Title: **DOOR CHECK NOISE**

Models: '00 – '01 Avalon

**BODY**  
**B0018-01**

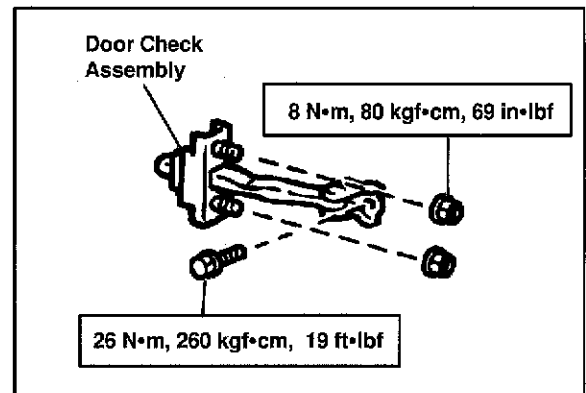
**Method A – Loose/Damaged Screw**

1. Remove the screw that attached the door check to the pillar.
2. Check for damage to the screw's threads.
3. If no damage, reinstall and tighten the screw to the specified torque.
4. If damaged, replace the screw and tighten the screw to the specified torque.
5. Cycle the door to confirm the noise was corrected.
